STAFF REPORT

DATE: 9/28/2021
TO: City Council
FROM: Sonya Allen, Associate Planner
208-884-5533
SUBJECT: FP-2021-0046
Artemisia Subdivision

Request for final plat consisting of seven (7) building lots on 19.26 acres of land in the C-G zoning district for Artemisia Subdivision.

C. Landscape Plan (dated: 3/2/21)

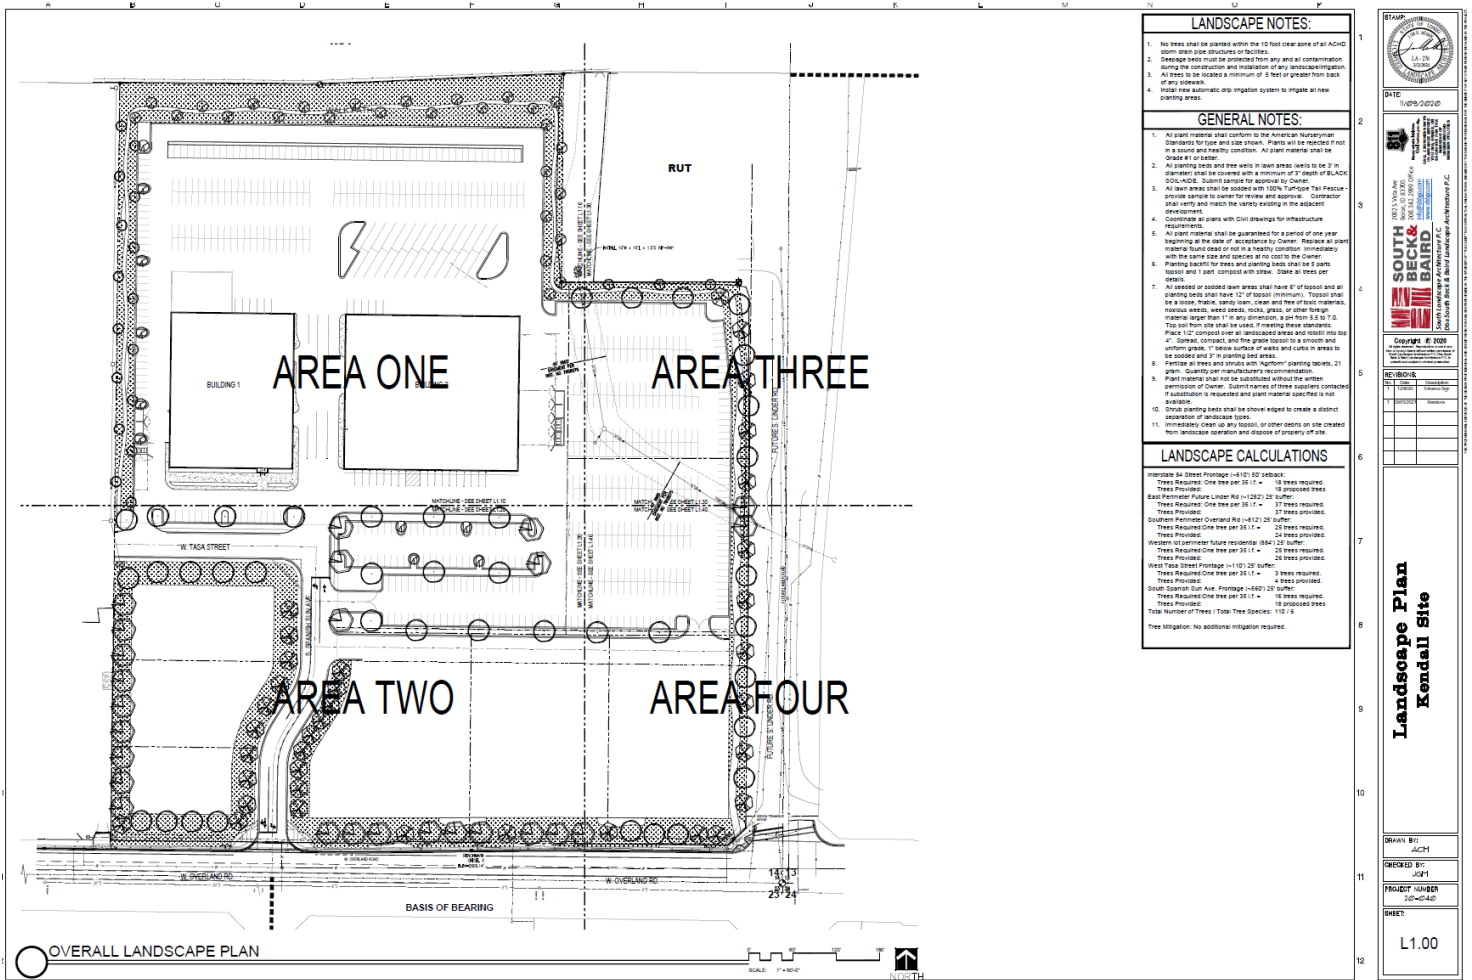
5. The landscape plan prepared by South Beck and Baird, dated 3/2/21 included in Exhibit C, shall be revised as follows:
 - a. Depict minimum 6-foot wide parkways/planting strips and detached minimum 5-foot wide sidewalks along all streets within the development per the Development Agreement. *The minimum width of parkways planted with Class II trees is 8-feet; the minimum width of parkway planters for Class I and III trees is 10-feet. Planter widths for Class II trees may be reduced to 6-feet if root barriers are installed per the standards listed in UDC 11-3A-17E.*

- b. Sidewalks/pathways shall include dedicated crosswalks at the intersection with all streets within commercial activity centers and shall be distinguished from surrounding paving per the Development Agreement.

- c. Change the fencing material around the Kendall Ford site to a higher quality than chain-link (i.e. wrought iron), per the Development Agreement.
 - d. Include one (1) additional tree in the southern perimeter street buffer along W. Overland Rd. to comply with UDC 11-3B-7C.3b.

- e. In the Landscape Calculations table, include calculations that demonstrate compliance with the standards for pathway (11-3B-12C) and parkway (11-3B-7C) landscaping; include required vs. provided number of trees.
